Borehole site response study

Figure 2.5-210 Contours of Top of Zone III-IV

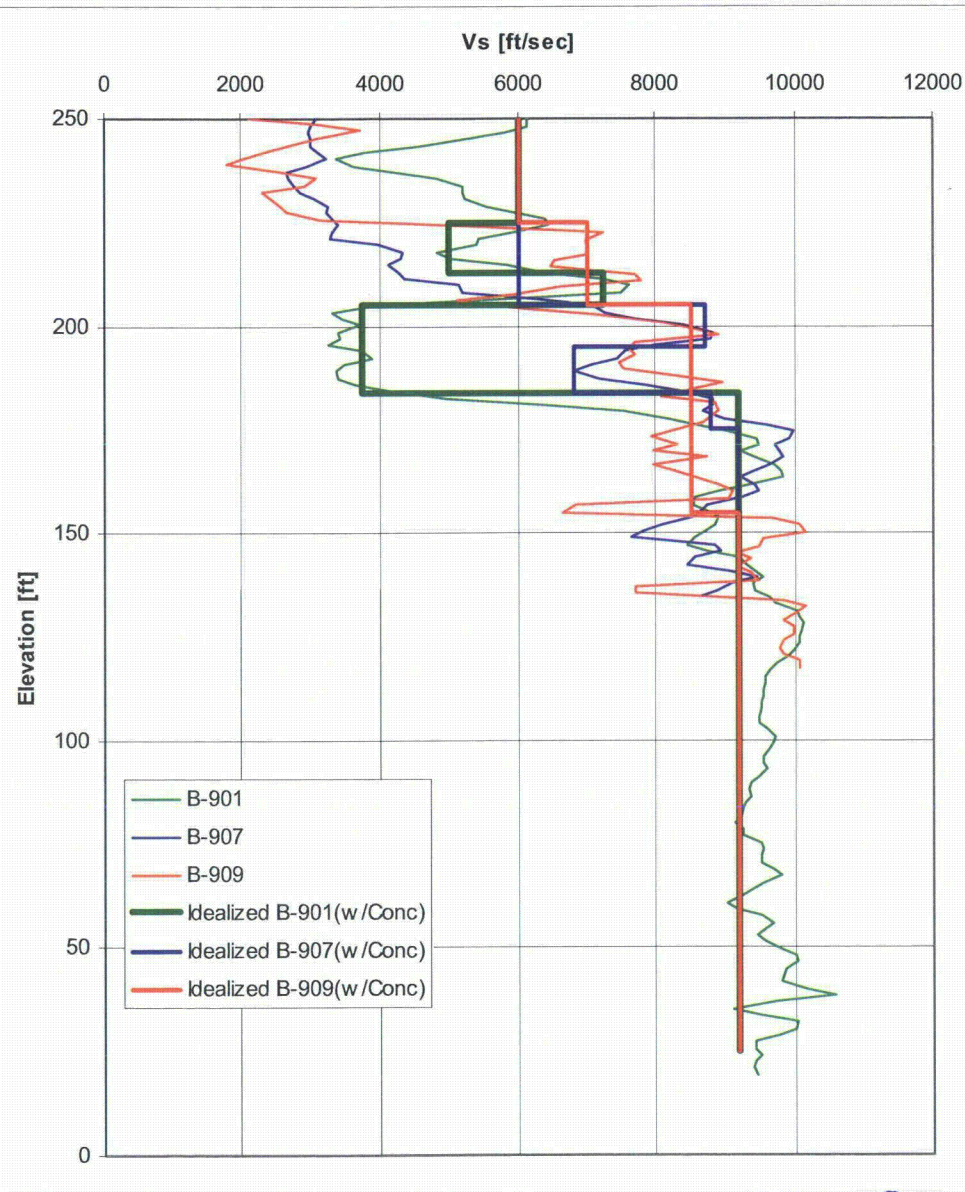
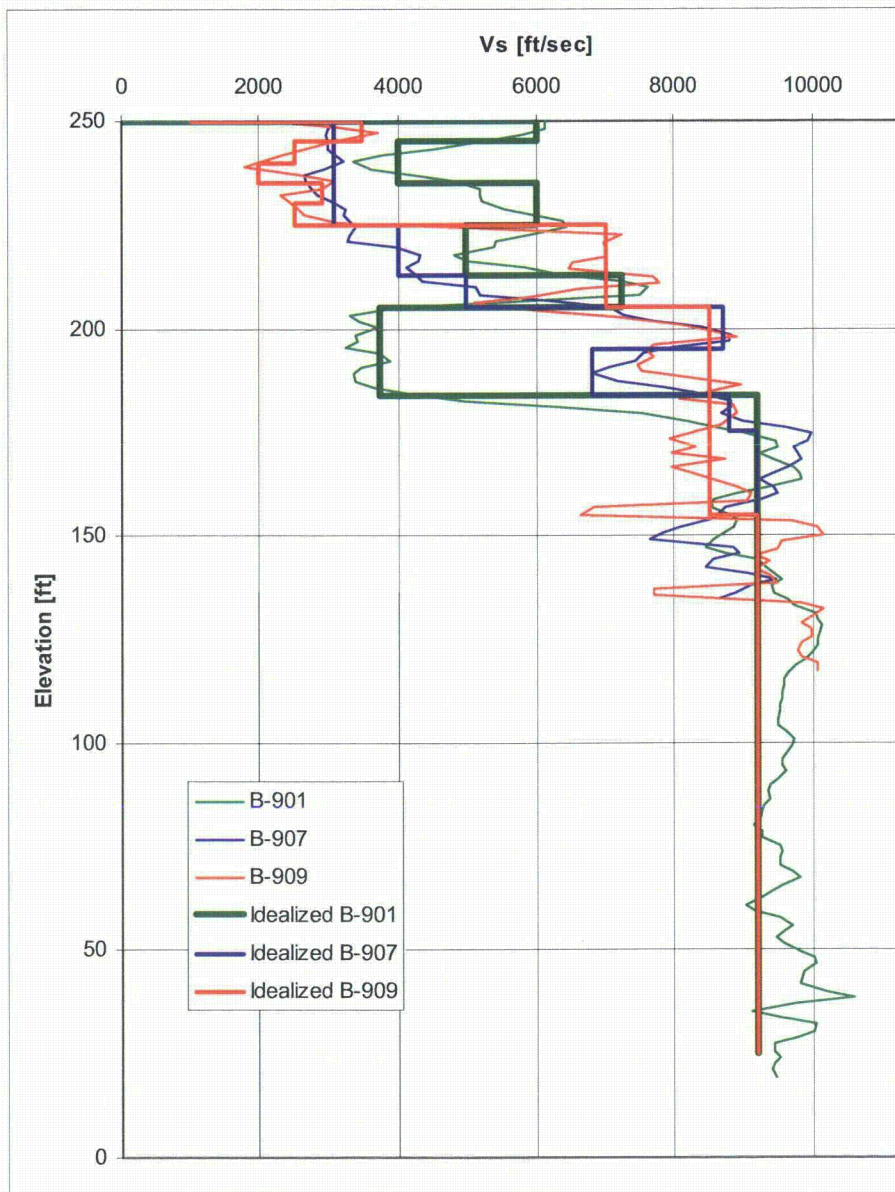
FSAR
3.7.2.1
needs to change ACI
